1st Further Information

**Proposed Temporary Warehouse (excluding Dangerous Goods Godown) with Ancillary
Open Storage of Construction Materials and Facilities for a Period of 3 Years in
“Other Specified Use” annotated “Railway Reserve” Zone,
Lot 4115 (Part) in D.D. 104, Kam Tin, Yuen Long, New Territories**

(S.16 Planning Application No. A/YL-KTN/1222)

Responses-to-Comments

Title:
Proposed Fire Service Installation
Layout Plan

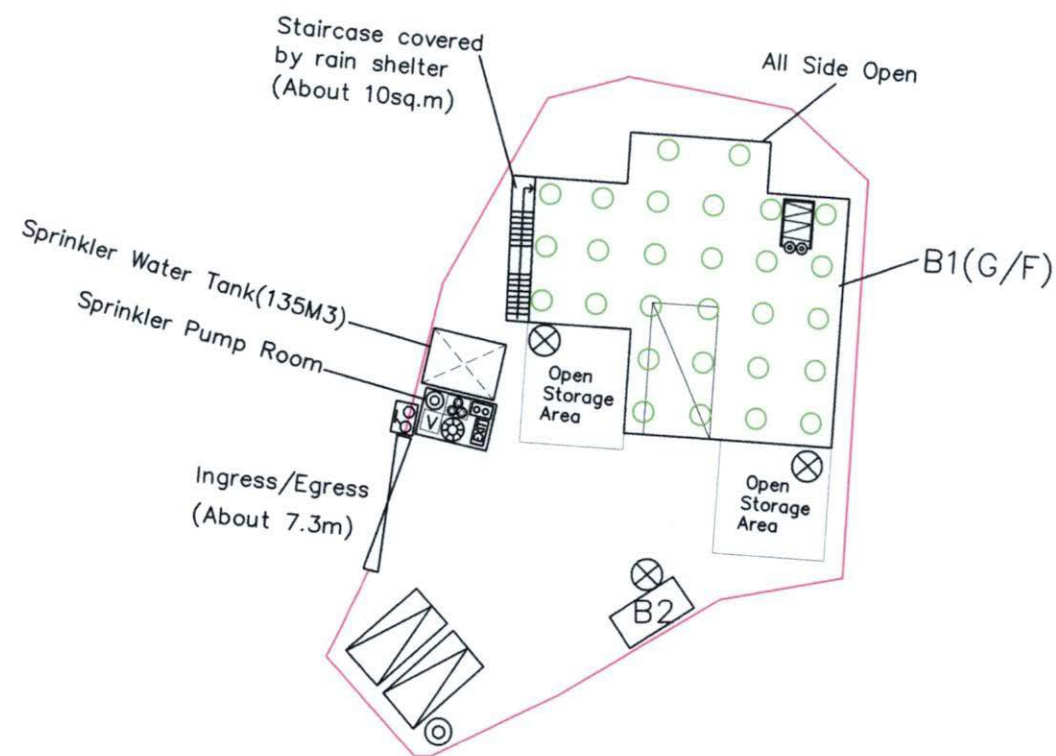
3. Comments of the Director of Fire Services (Contact Person: Mr. YUEN Tsz-fung; Tel: 2733 7737)		
(a)	For enclosed structure with gross floor area exceeding 230 m ² , sprinkler system, wheeled type dry chemical fire extinguisher, stand-alone fire detector, emergency lighting and directional & exit signs shall be provided;	A revised fire service installations proposal has been provided by the applicant (Annex I). The sprinkler system, wheeled type dry chemical fire extinguisher, stand-alone fire detector, emergency lighting

and directional & exit signs are provided accordingly.
(b)	In relation to item (i) above, if two or more stand-alone fire detectors are installed in an enclosed structure, all detectors shall be interconnected (either wired or wirelessly) such that when one of the detectors is triggered, all connected detectors shall sound an alarm simultaneously;	Noted.

(c)	Stand-alone fire detectors shall be provided in accordance with the "Stand-alone Fire Detector General Guidelines on Purchase, Installation & Maintenance [Sep 2021]";	Noted.

(d)	A 20-35 kg wheeled type dry chemical fire extinguisher shall be provided in every 500 m ² on every floor of the premises and ensure that every part of the premises can be reached from a distance of not more than 30 m;	Noted and provided accordingly.

(e)	Emergency lighting shall be provided in accordance with "BS 5266-1:2016, BS EN 1838:2013 and the FSD Circular Letter No. 4/2021";	Noted.
(f)	Directional and exit signs shall be provided in accordance with "BS 5266-1:2016 and the FSD Circular Letter No. 5/2008"; and	Noted.

4. A 20-35kg Wheeled Type Dry Chemical Fire Extinguisher in every 500sq.m on every floor of the premises B1 and shall be provided to ensure that every part of the premises B1 can be reached by wheeled type dry chemical fire extinguisher from a distance of not more than 30m.

5. Sufficient Stand-alone Fire Detector shall be provided for each enclosed structure. The Stand-alone Fire Detector shall be provided in accordance with the "Stand-alone Fire Detector General Guidelines on Purchase, Installation & Maintenance [Sep 2021]".
where two or more Stand-alone Fire Detectors are installed in an enclosed structure, all Stand-alone Fire Detectors shall be interconnected (either wired or wirelessly) such that when one of the Stand-alone Fire Detector triggered, all connected Stand-alone Detectors shall sound an alarm simultaneously.

6. An Automatic Sprinkler System Supplied by 135 m³ Sprinkler Water Tank and Hazard Class OH 3 shall be provided to the building/structure 1 in accordance with BS EN 12845:2015 and FSD Circular Letter No.5/2020. The Sprinkler Inlet and Sprinkler Control Valve Group as marked on plans. & the sprinkler water tank, Sprinkler pump room as marked on plans too.
